Well Name: SAN JUAN 28-7 UNIT	Well Location: T27N / R7W / SEC 29 / SESW / 36.539291 / -107.601532	County or Parish/State: RIO ARRIBA / NM
Well Number: 15	Type of Well: CONVENTIONAL GAS WELL	Allottee or Tribe Name:
Lease Number: NMNM03560	Unit or CA Name: SAN JUAN 28-7 UNIT--PC	Unit or CA Number: NMNM78413B
US Well Number: 300390687900S1	Operator: HILCORP ENERGY COMPANY

Notice of Intent

**HILCORP ENERGY COMPANY**  
**SAN JUAN 28-7 UNIT 15**  
**P&A NOI**

Well: San Juan 28-7 Unit 15

**SAN JUAN 28-7 UNIT 15 - PROPOSED WELLBORE SCHEMATIC**

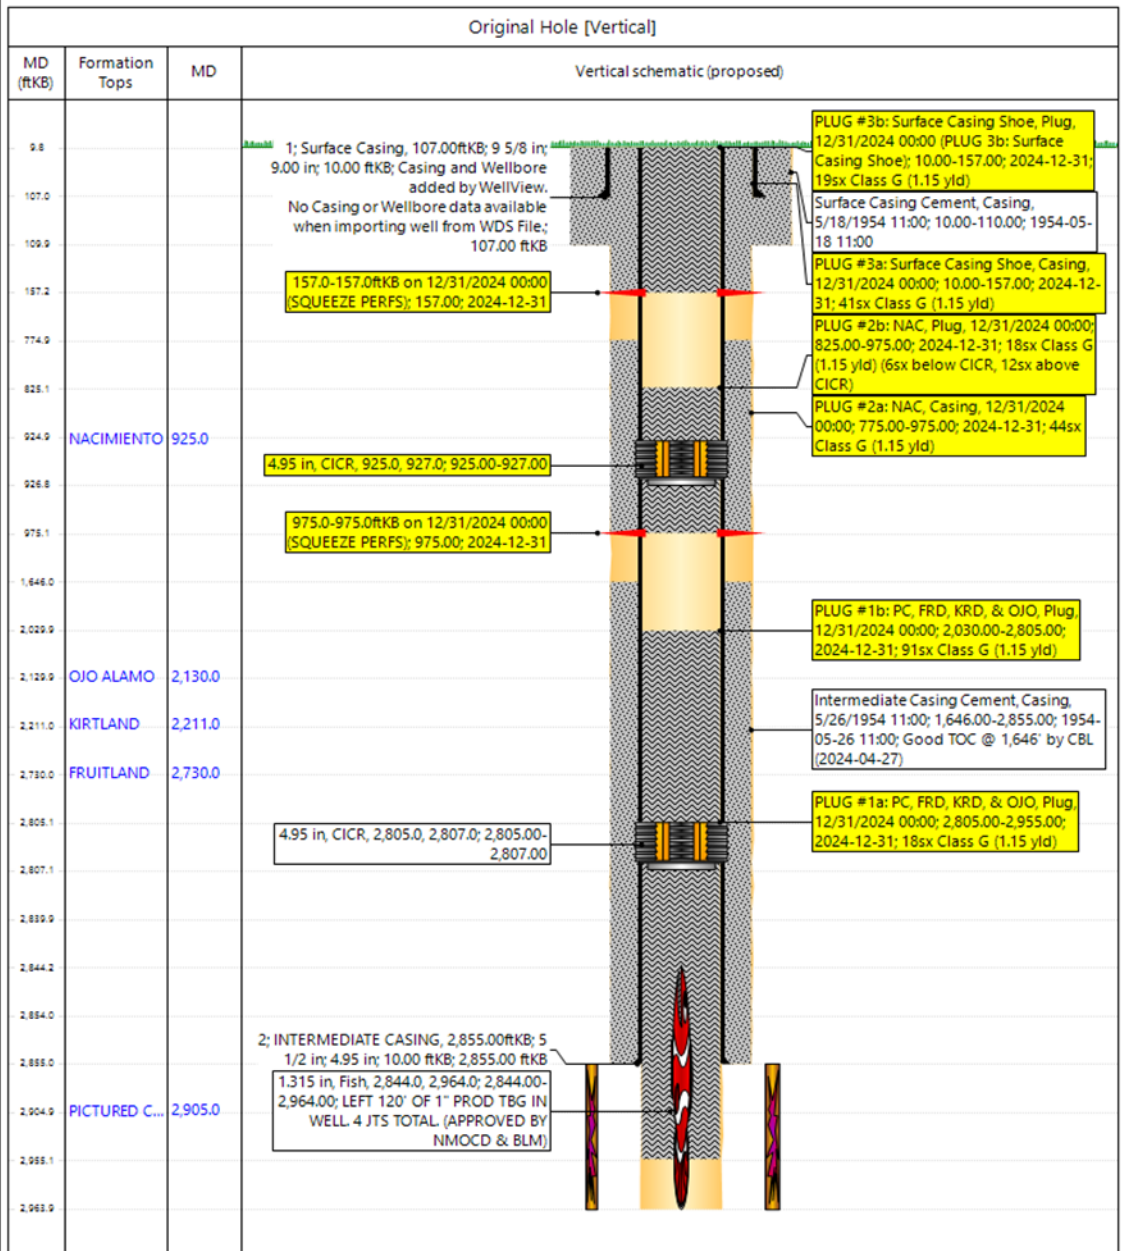
Changes may be asked to be done for the Nacimiento plug after additional review.

Created By	Condition	Condition Date
mkuehling	Extend Ojo plug to 2009 to cover NMOCD top for OJO at 2109 - Rig is on well no notification is necessary - Monitor string pressures daily report on subsequent - If pressure on bradenhead cannot go past Kirtland top	4/29/2024
